The Commission has issued the enclosed Amendments Nos. 20 and 25 to Facility Operating Licenses Nos. DPR-24 and DPR-27 for the Point Beach Nuclear Plant, Units Nos. 1 and 2. The amendments consist of changes to the Technical Specifications and are in accordance with your application dated October 10, 1975 and supplements dated July 12 and August 12, 1976.

POINT BEACH NUCLEAR PLANT, UNIT NO. 1

AMENDMENT TO FACILITY OPERATING LICENSE

SAFETY EVALUATION BY THE OFFICE OF NUCLEAR REACTOR REGULATION
SUPPORTING AMENDMENTS NOS. 20 AND 25 TO FACILITY LICENSES DPR-24 AND 27

Figure 15.4.10-1 Sampling Locations

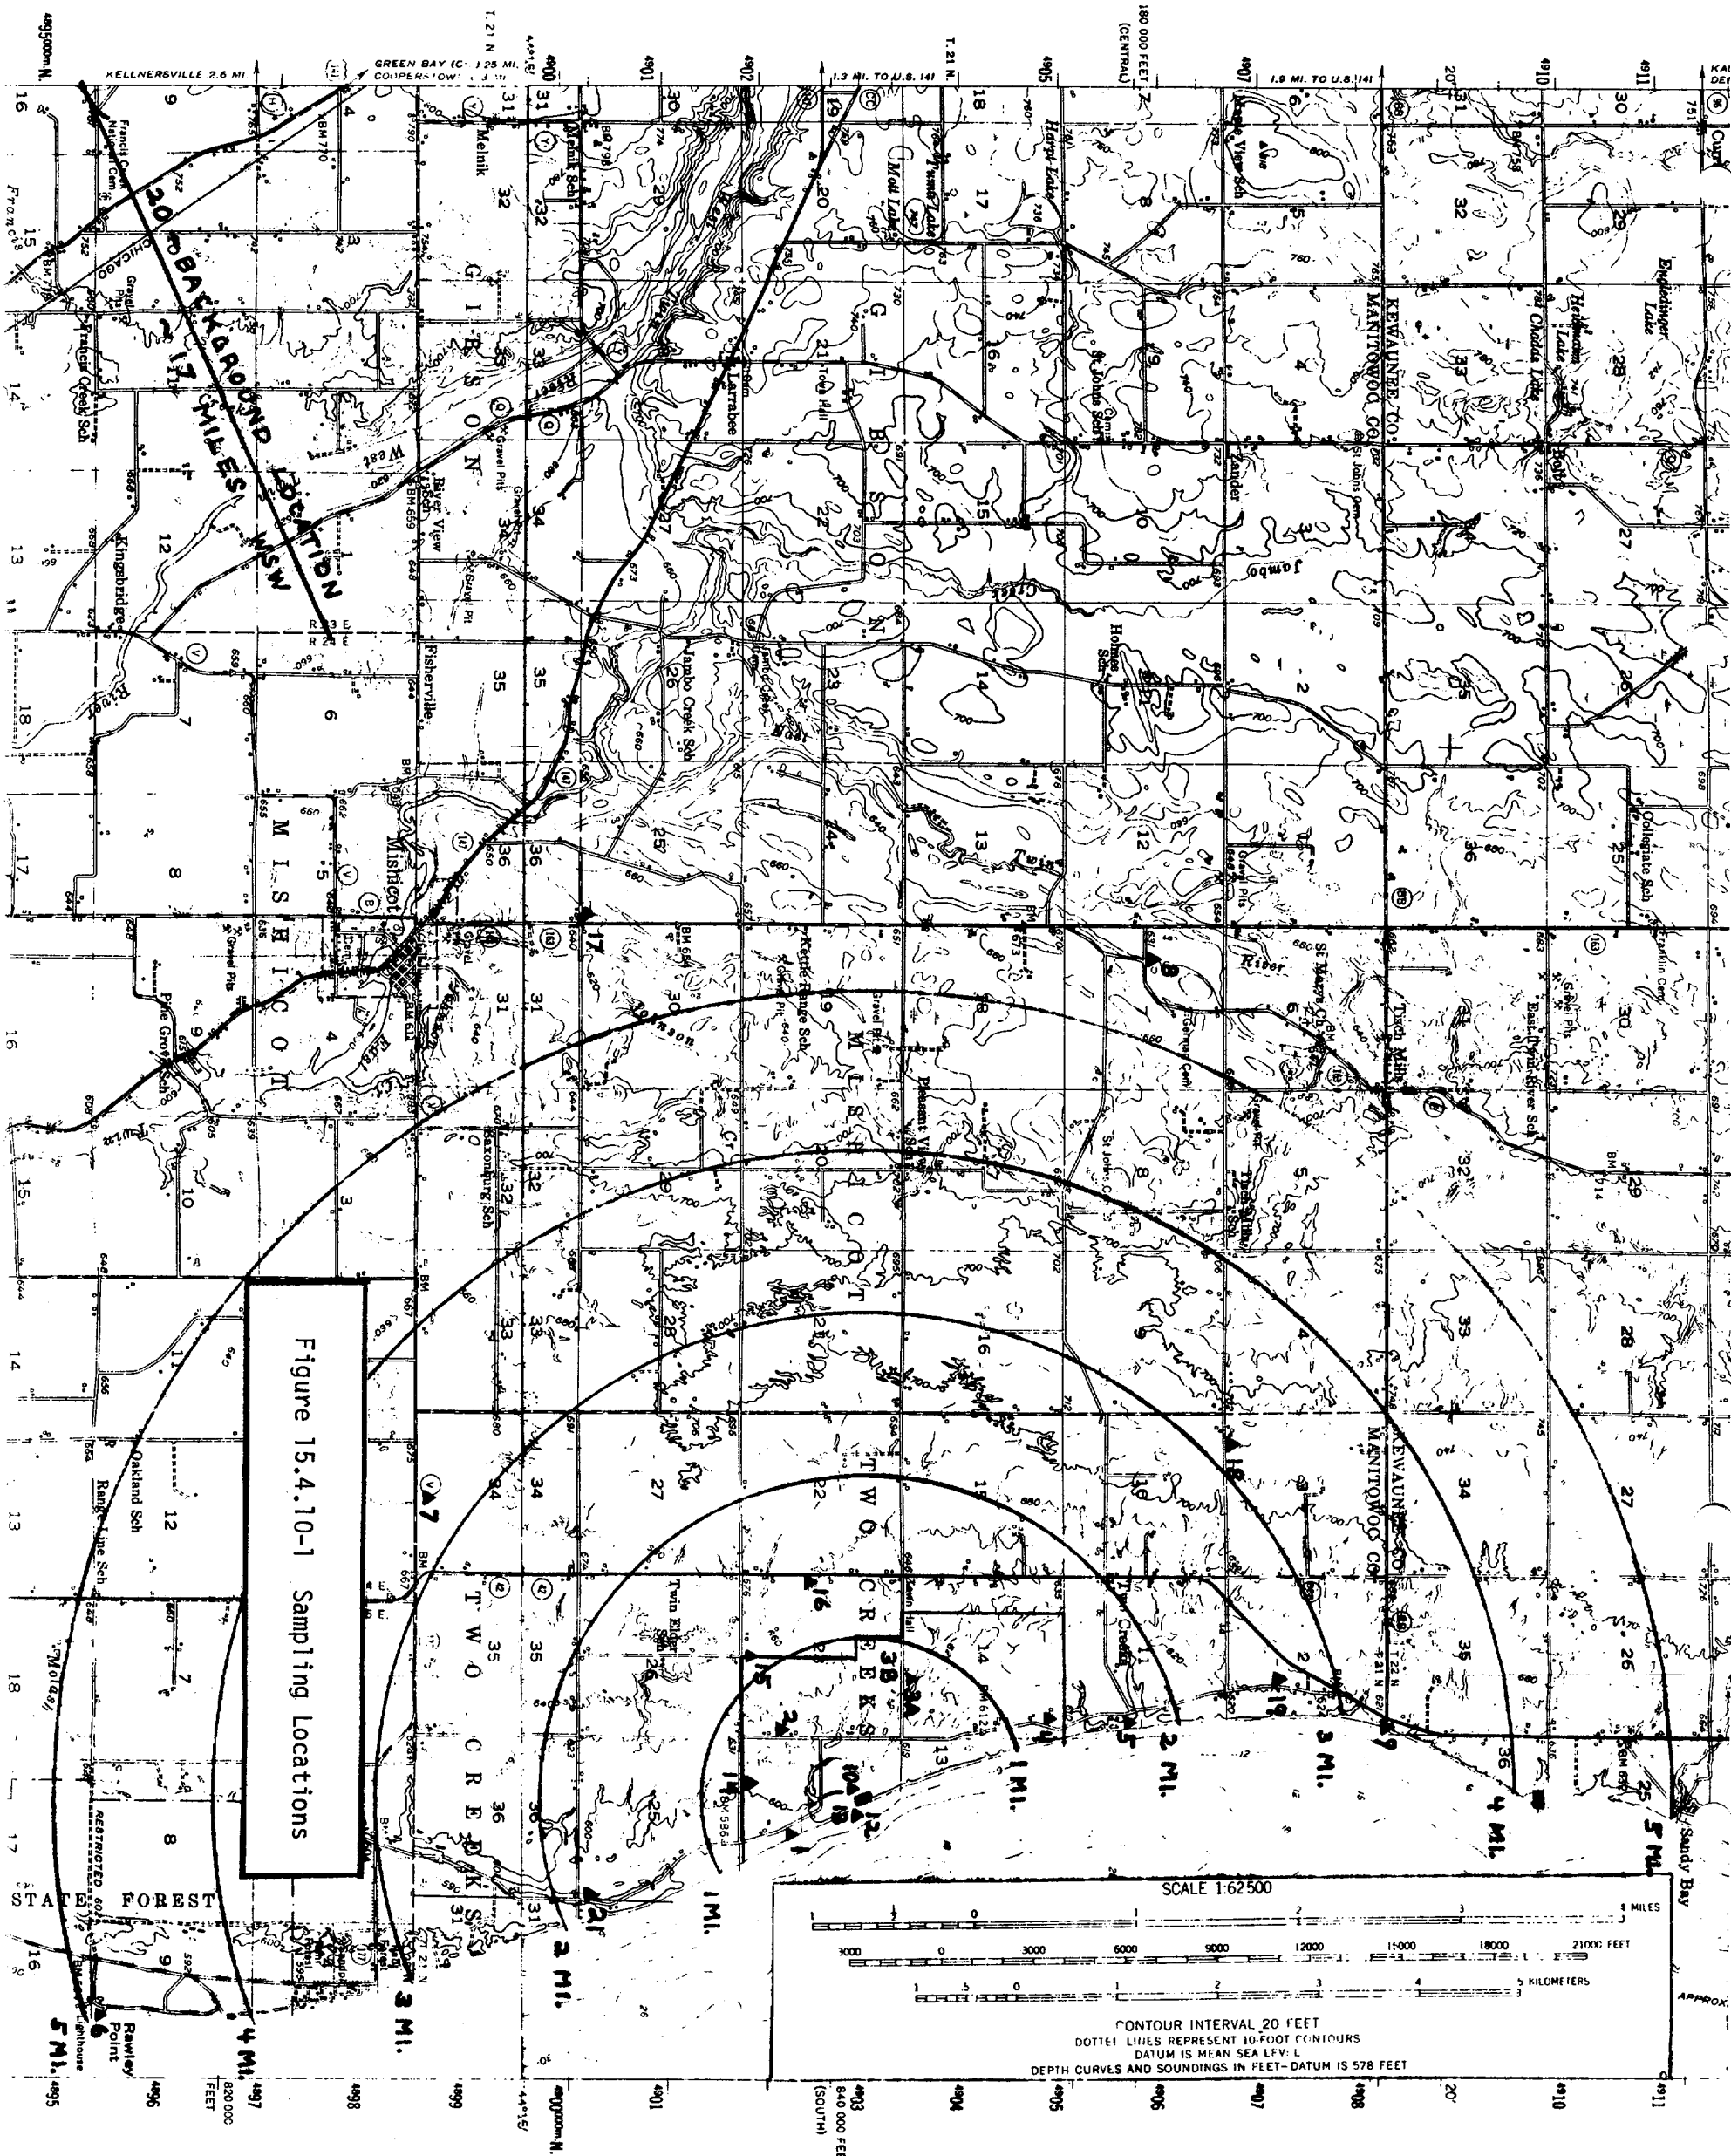
Replace pages 15.4.10-1 and 15.4.10-2 with the attached revised pages.
Add Table 15.4.10-1 (Page 1 of 2 and Page 2 of 2) and Table 15.4.10-2
(Page 1 of 2 and Page 2 of 2), and Figure 15.4.10-1.

1. Environmental samples shall be taken at locations indicated in Figures 15.4.10-1, according to the schedule given in Table 15.4.10-1 and the analytical criteria given in Table 15.4.10-2.
